▲ = Revised January 2001

Exhaust Manifolds, Risers and Exhaust Elbows

Models

All standard V6 and V8 gasoline engines with center outlet exhaust manifolds.

Fastener Torque Change

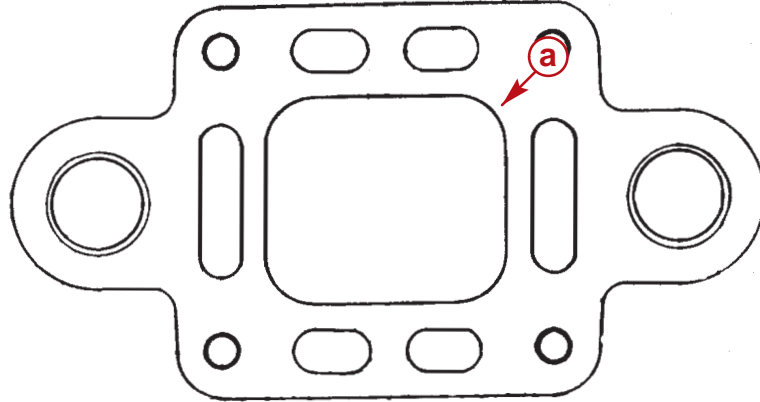
33 lb-ft (45 Nm). Use this new torque on all fasteners when installing exhaust elbows or risers onto exhaust manifolds.
